Summary: HIRDLS Unverified Failures

MISSION SUCCESS REVIEW QUESTIONS FOR UNVERIFIED FAILURES

Program HIRDLS Spacecraft EOS Subsystem CSS Box CCU

Title: CCU Caging Circuit Relay

Figure 1. Chopper in balancing fixture showing photodetector leads near cradle at the point at which leads enter connector.

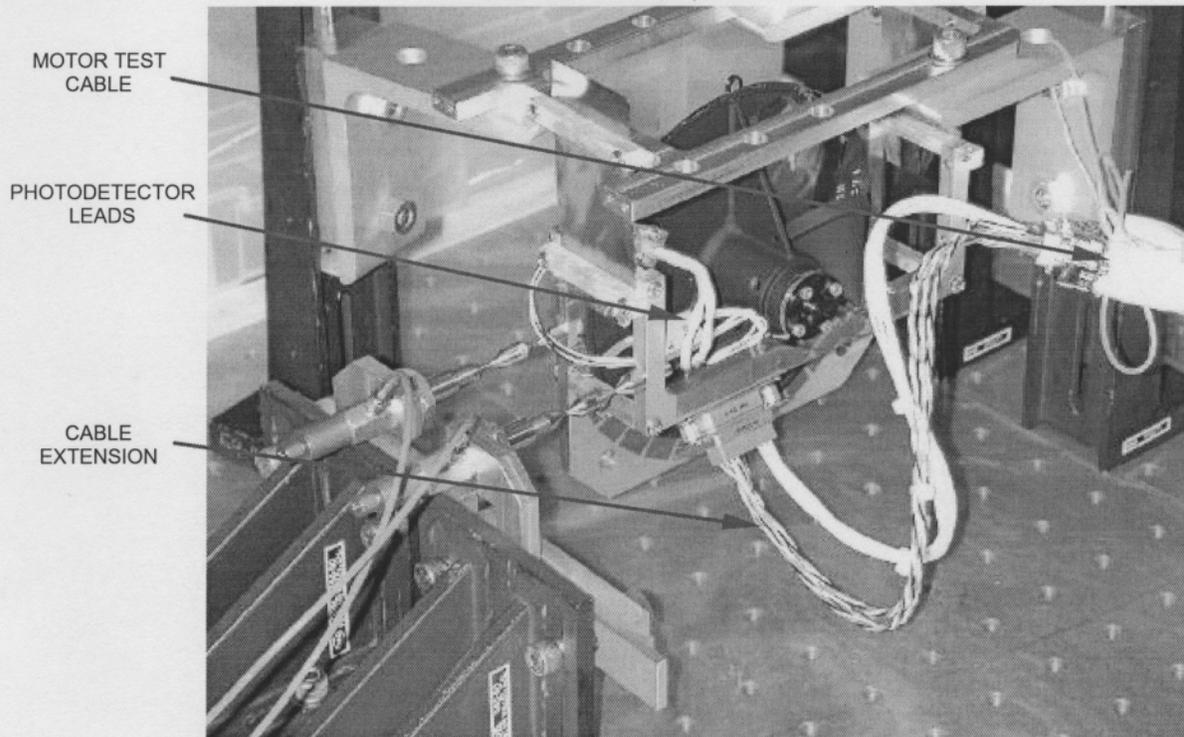
Troubleshooting: Connectors on the motor cable were verified to be securely mated. Fluctuations continued. Leads from the chopper motor connector to the photodetectors mounted on the chopper were noted to be in contact with the balancing fixture cradle. To eliminate a potential error in balance measurement the lay of the leads was adjusted (see figure 1). At this point speed fluctuations stopped. A search for a potential intermittent was conducted by flexing chopper leads while monitoring speed (per DR# AB5509). No further fluctuations were observed as leads for the optical emitters, photodetectors, and cable extension were flexed. Testing was performed with the chopper shaft horizontal and vertical. Leads were flexed in all directions at each end and in the middle. Leads were x-rayed to look for breaks, shorts, debris, and full contact insertion in connector shells. No defects were found. The test cable and cable adapter were inspected for proper assembly and debris. No defects were found.

Figure 1 Slew rate vs temp. Temp cycle -12 to +35 then back to ambient. The 20 C data was from the final ambient temperature.

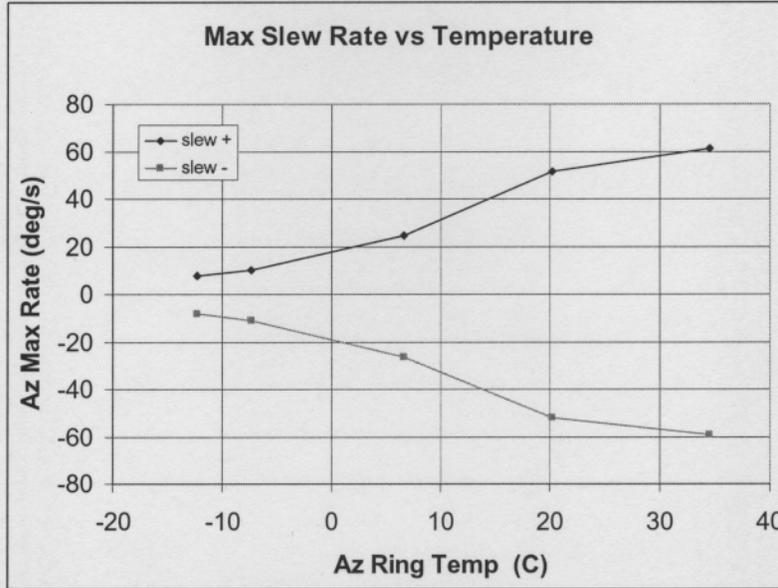
- (1) When the scan mirror assembly was less than 10C, the azimuth was not able to reach the specified sweep rates of 10 deg/s as shown in Figure 1. The root cause for this is increased viscosity with low temperature of the lubricant used for the azimuth axis bearings. The disposition was to attach operational heaters to maintain SMA temperatures at 10C or higher.

Figure 2 Slow az (0.2 deg/s +/- 2 deg). Hot result is after starting at 0,0 while ramping from ambient to hot. This plot shows torque required for the initial move at hot compared to ambient and later hot move.

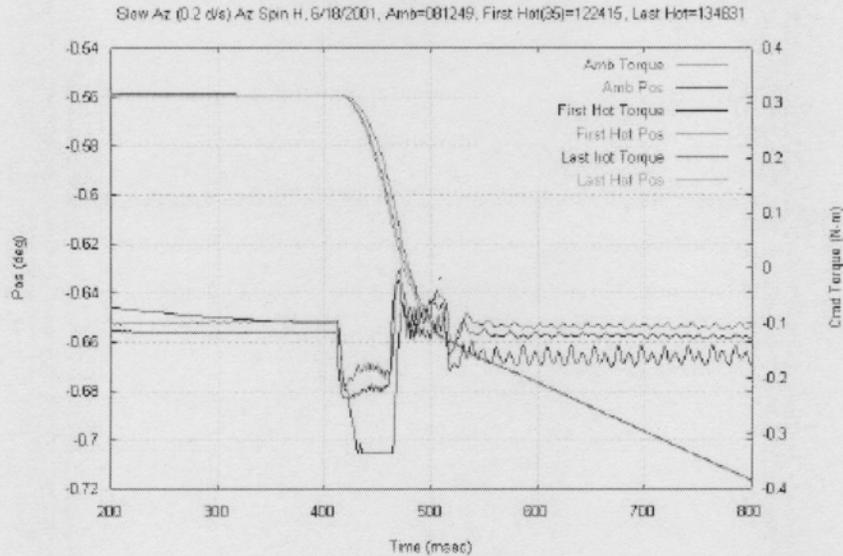
- (2) When the scan mirror was stationary during a thermal cycle from colder to hotter temperatures, the first azimuth move required a higher torque than normal to break stiction. Successive moves required the nominal torque expected for the given temperature. An example is shown in Figure 2.

Figure 4 Test A analysis comparing H and V results following lower temperature to warmer temperature cycle with an offset applied to H torque to compensate for gravity effect.

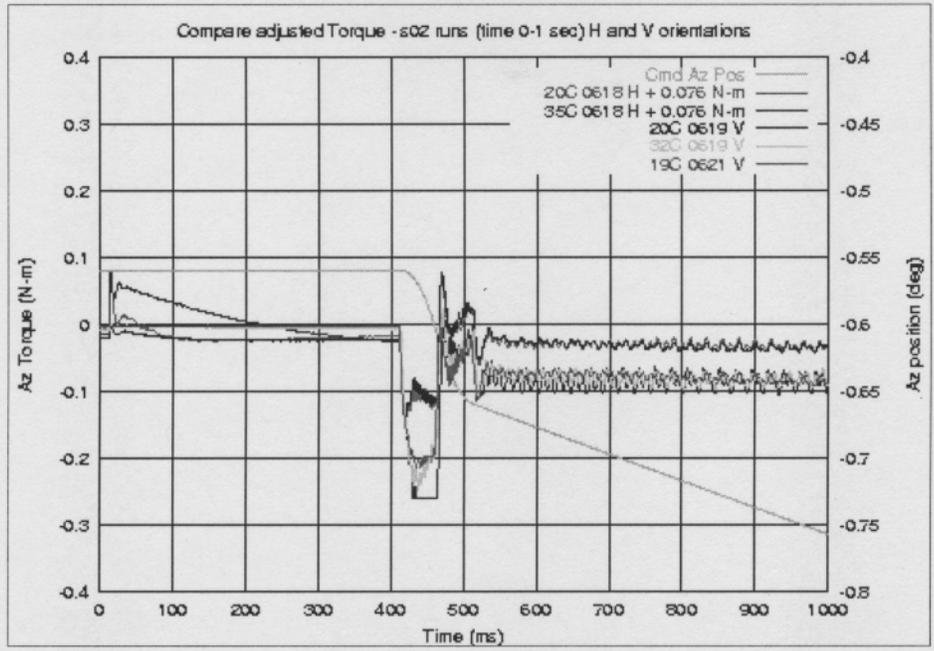
- (3) In one case, the scan mirror azimuth axis did not break stiction with the application of the maximum available torque. Repeated application of the maximum torque did eventually free the axis and normal operation resumed. . As shown in Figure 3, each attempt resulted in a successively larger move than the preceding attempt. This was the only instance in which the azimuth did not achieve break-away motion with the first attempt.

Figure 5 Torque data from all range sweep data taken during temperature cycling. This is the torque required to maintain a constant velocity once a constant rate has been achieved. (The 0603 cold data starts out with the negative torque limit of -0.335 N-m)

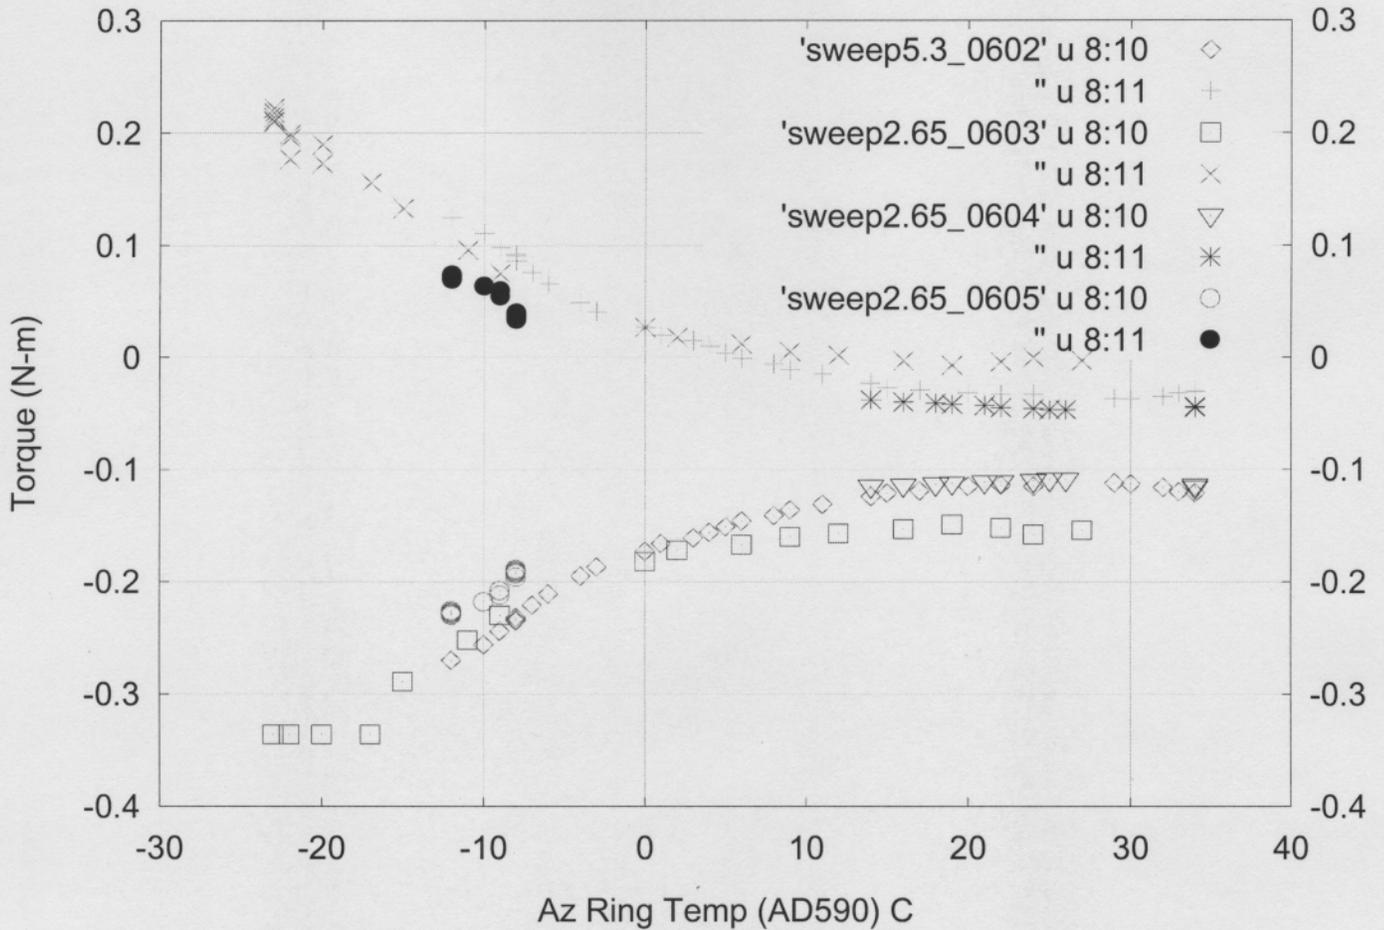
4. “Starting Friction” vs “Running Friction” Textbook treatments of bearings describe that the friction required to initiate motion in a roller bearing is 2X the friction needed to maintain steady state motion. This would translate into a torque requirement differing by a factor of 2 for “starting” vs “running”. For the HIRDLS SMA, the starting torque is consistently 2X of the running torque, see for example Figure 2. Since the maximum torque available is ± 0.335 N-m, the maximum running torque that can be accommodated is half of this value, or ± 0.17 N-m. A review of the “running torque” data for various test cases is shown below in Figure 5. There are two points to make with respect to these data:

- For the bearing to operate successfully, a running torque of less than ± 0.17 N-m is required. Inspection of the data show that this condition is achieved for all temperatures above 5 deg C. As part of the corrective action for Item #1 on this DR, operational heaters were installed to maintain the housing temperature at 10C or higher throughout the mission life.

- If gravity effects are accounted for, both curves would shift upwards by a factor of 0.07 N-m. When this change is factored in, the SMA is seen to have sufficient torque to operate successfully at temperatures as low as -10C.

5. Subsequent HIRDLS Program Analysis: This mechanism has insufficient torque ratio to perform global scan, to achieve 30 deg/sec rate, and to initiate the scan motion. In each of the three cases, the torque ratio is 1.2 vs required value of 2.0. HIRDLS Program office at GSFC agrees, program is pursuing design modification.
